SAND CREEK RESTORATION

SHEET 2 OF 81

SAND CREEK RESTORATION
EARTHWORK & PHASING
PLAN

**SECOND CREEK REACH 1 EAST REGIONAL TRAIL & MAINTENANCE ACCESS
STA 1+00.00 TO 11+70.00**

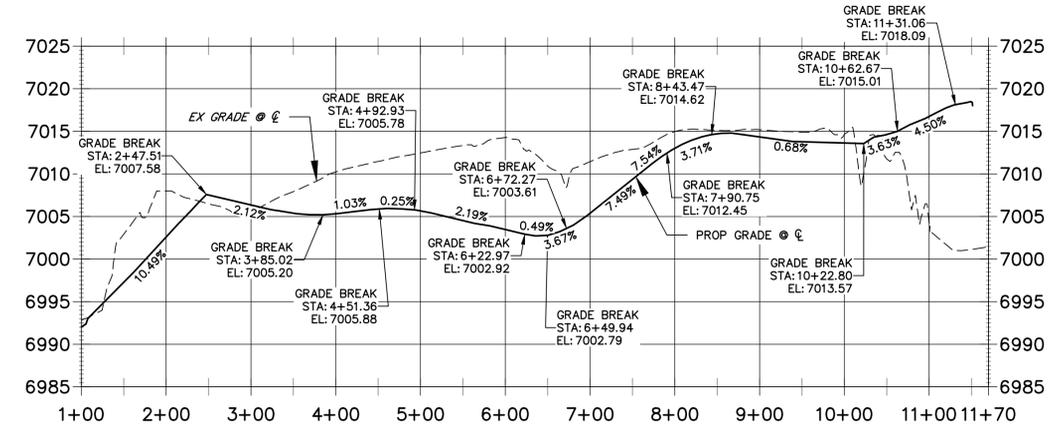
Provide plan for trail on west side

MAINTENANCE ACCESS PLAN & PROFILE

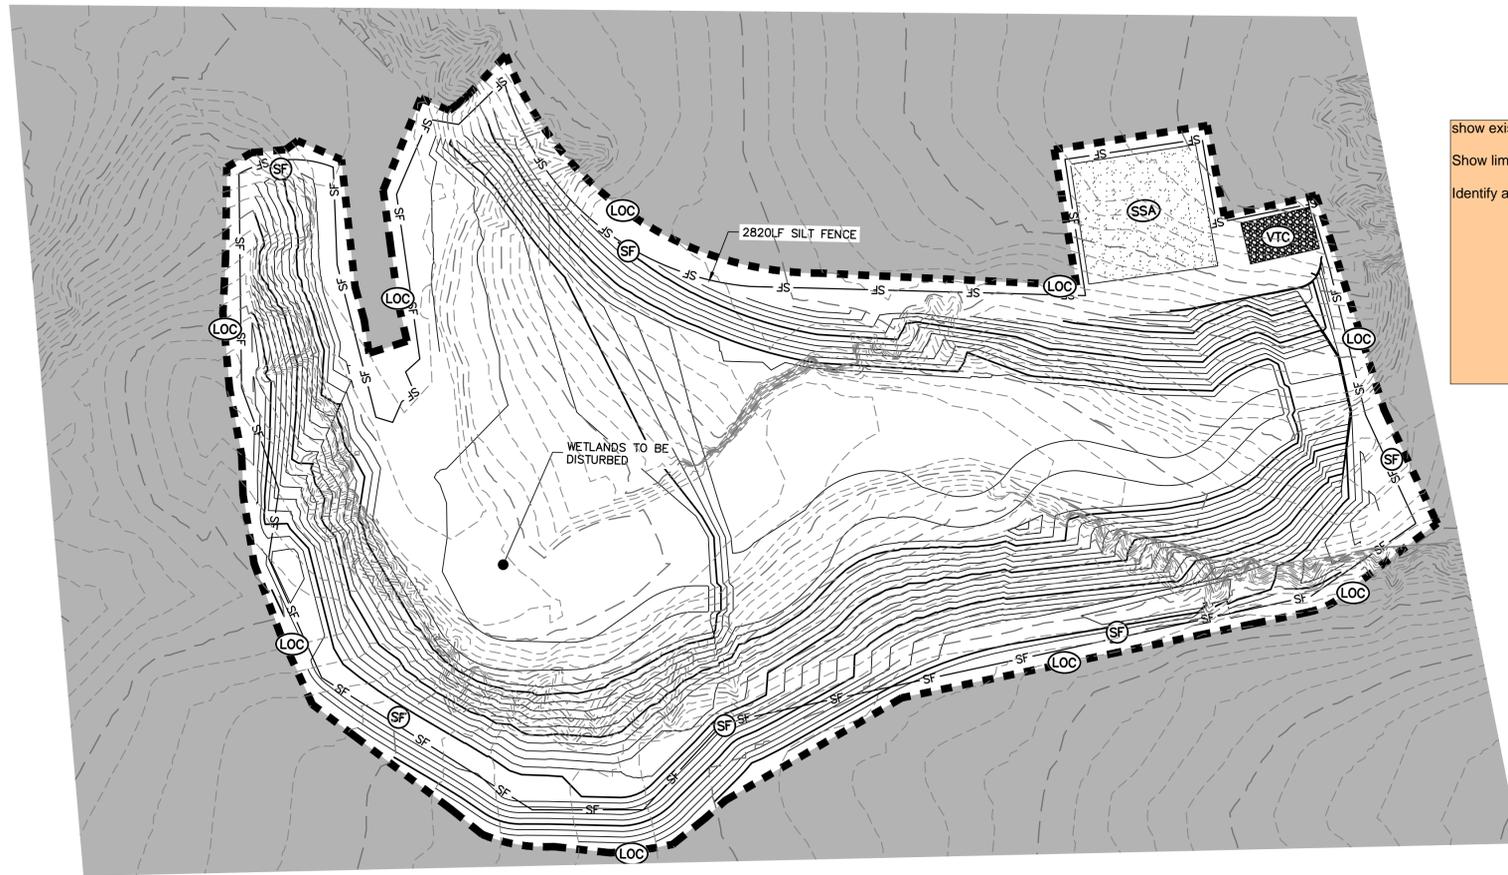
Show existing and proposed stormwater flow direction arrows.

Show limits of disturbance

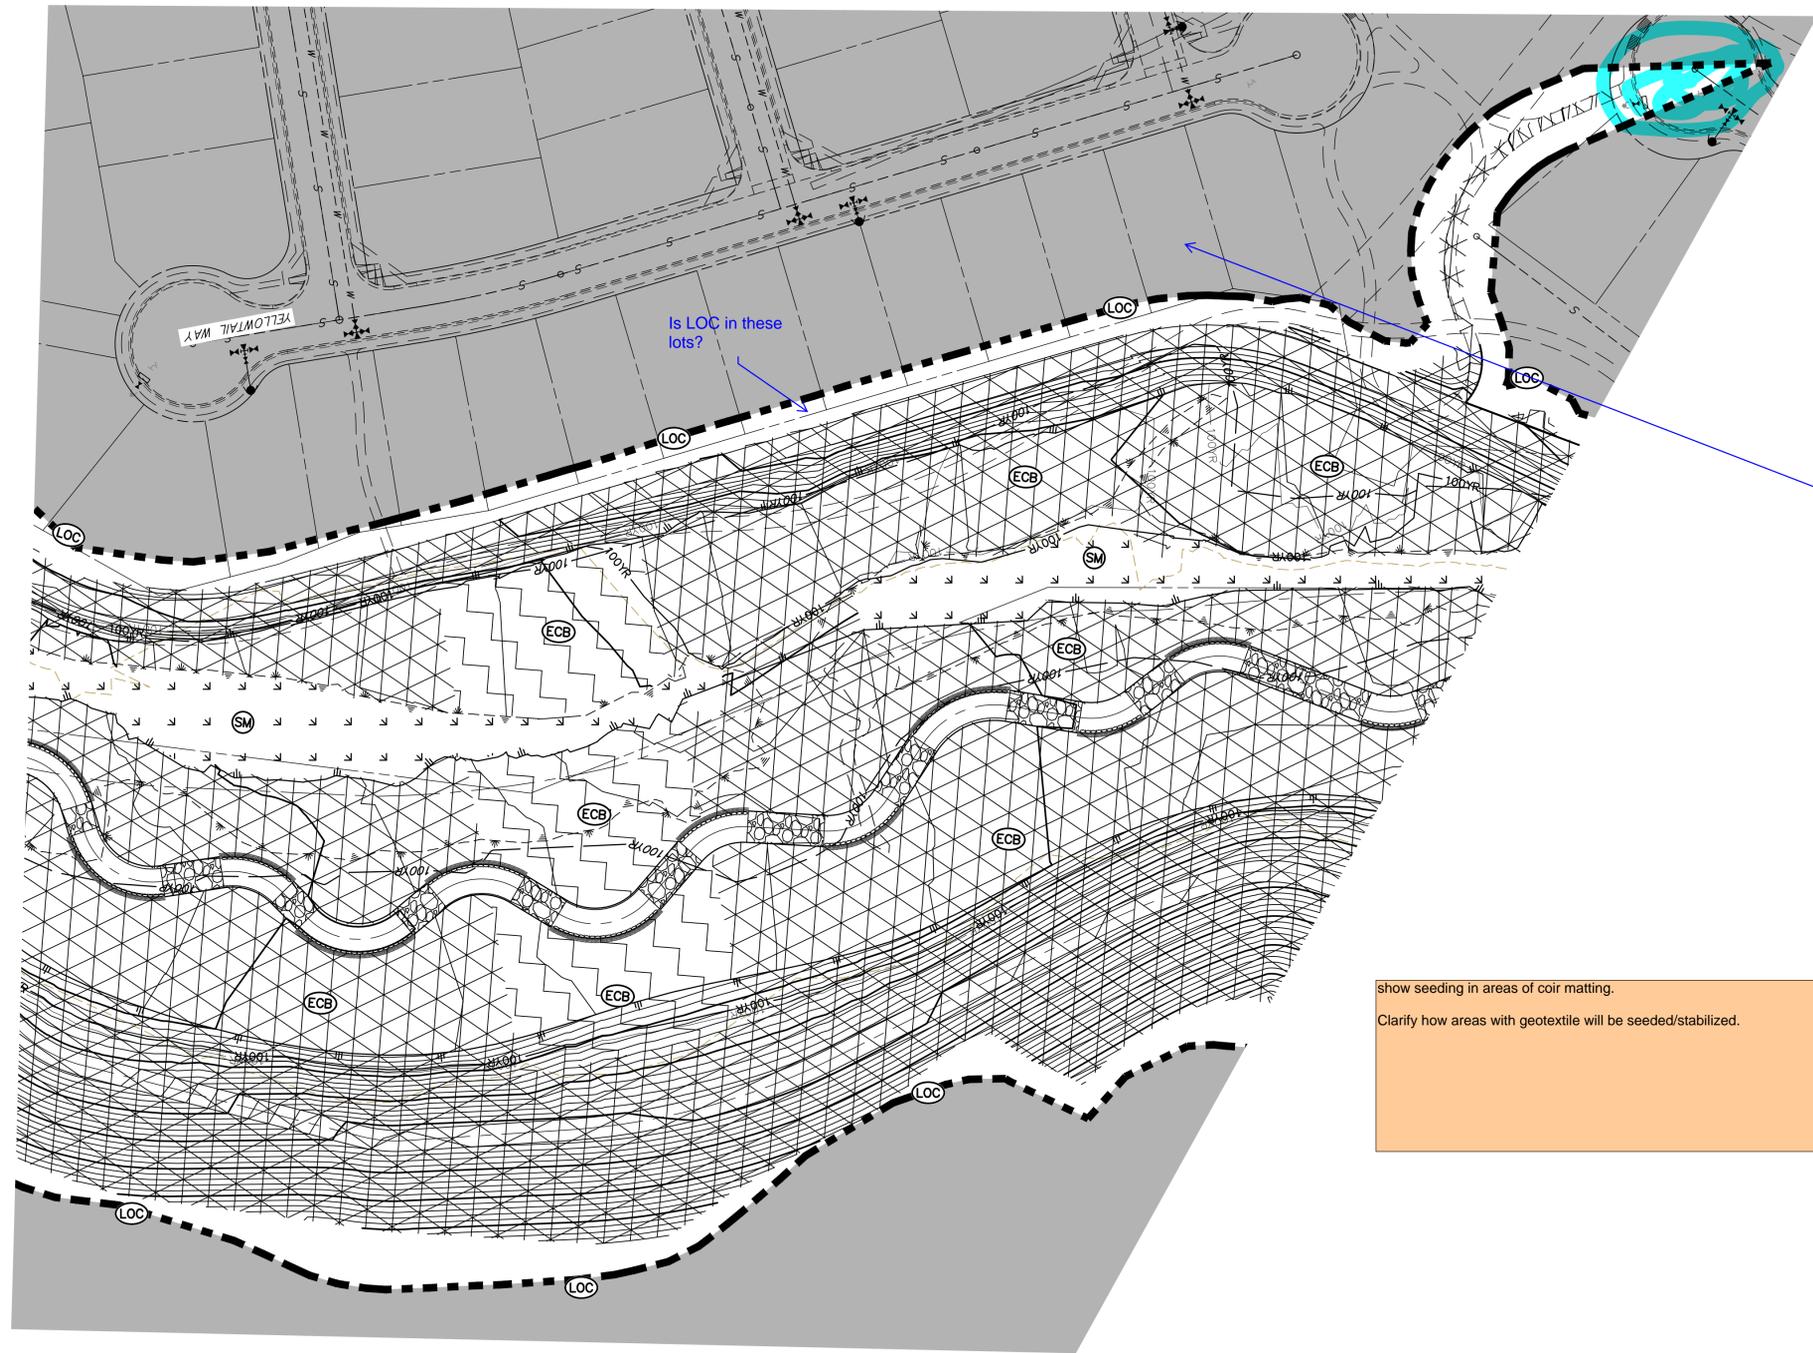
show seeding in areas of coir matting.
Clarify how areas with geotextile will be seeded/stabilized.

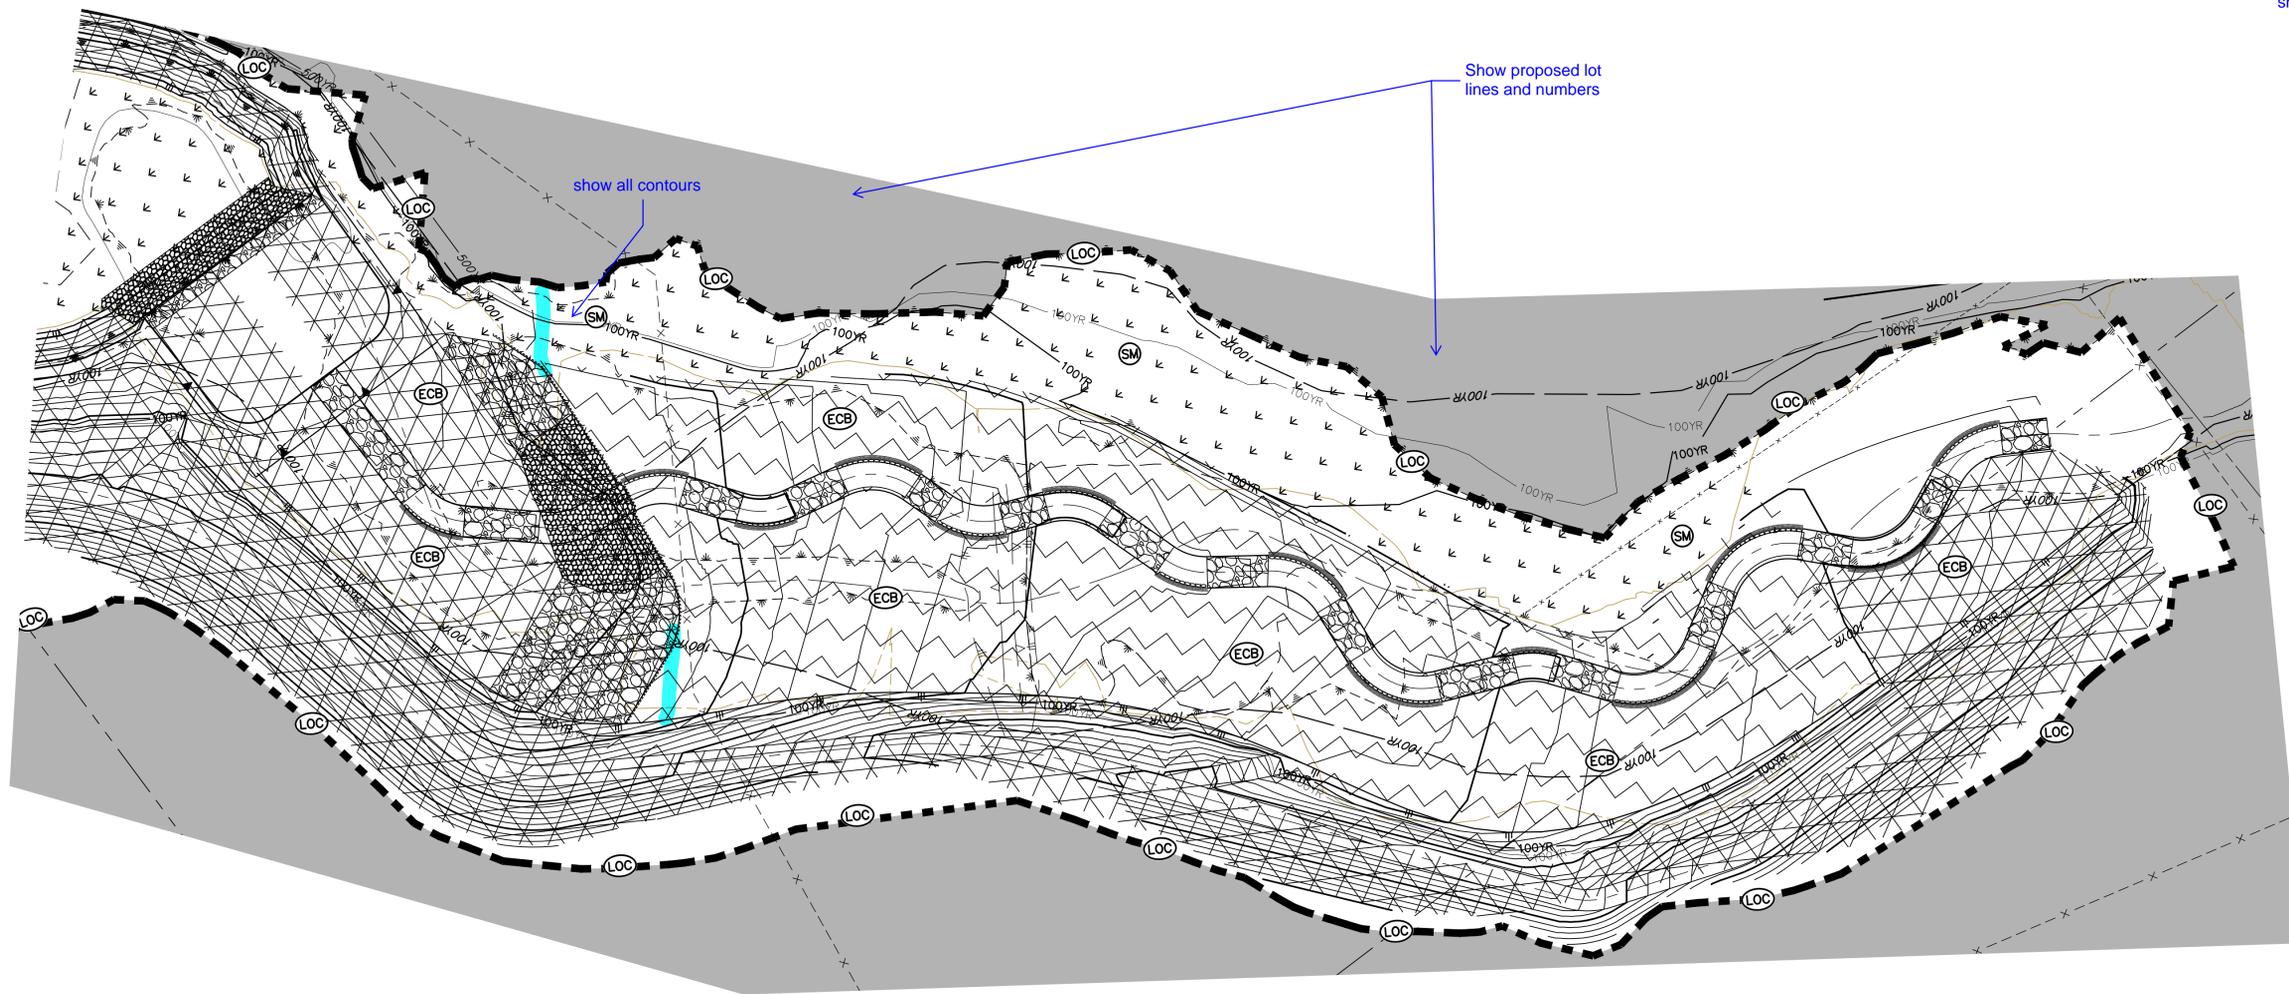
include all BMP details.
show all dewatering areas

add a note about existing vegetation
